Product code: CS16t-60

Description: 2E chassis EVO6 compatible

New product / replacement: Replaces CS16t

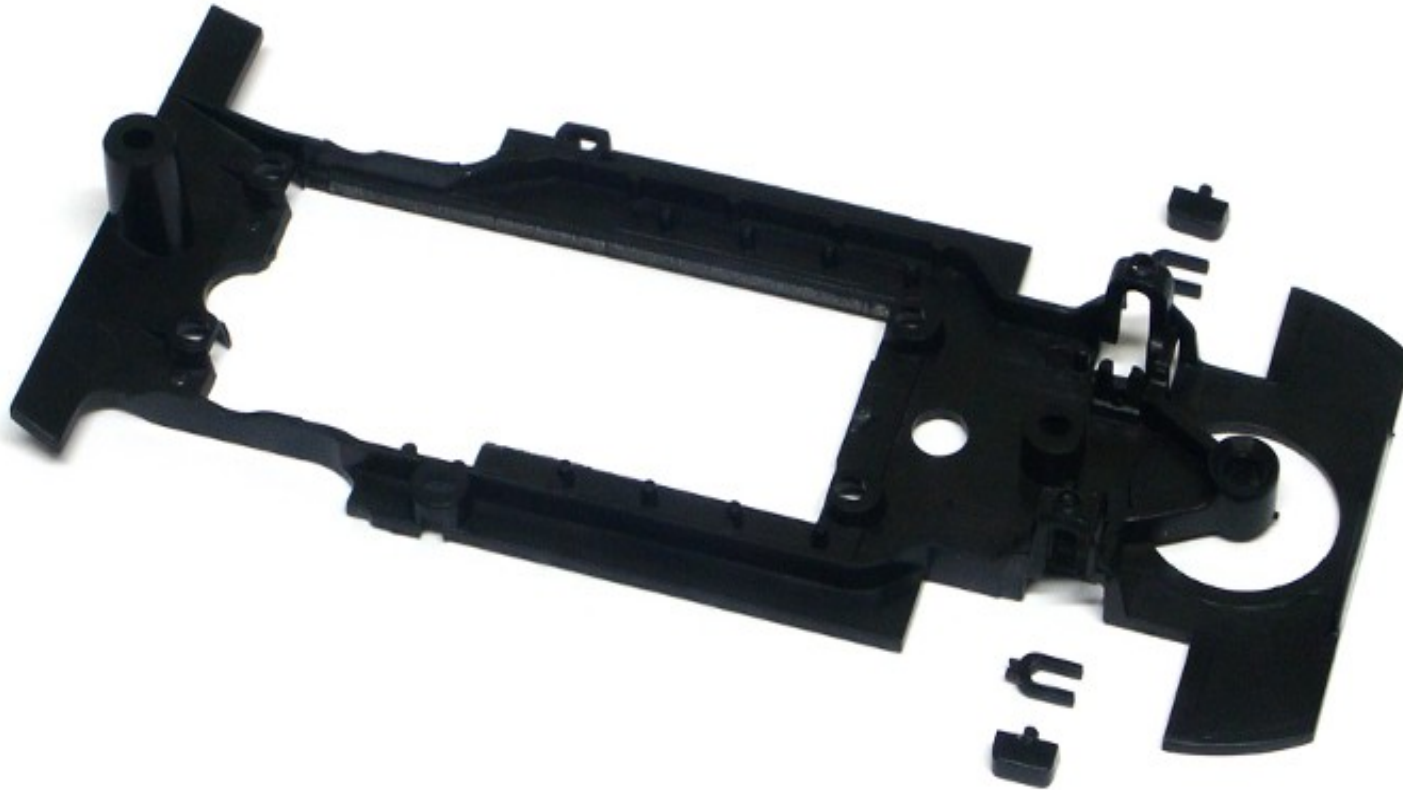
Difference from replaced item: new mould, compatible with EVO6, pickup location shifted up

- compatible with EVO6 sidewinder motor mounts
- pickup location shifted up to improve cornering
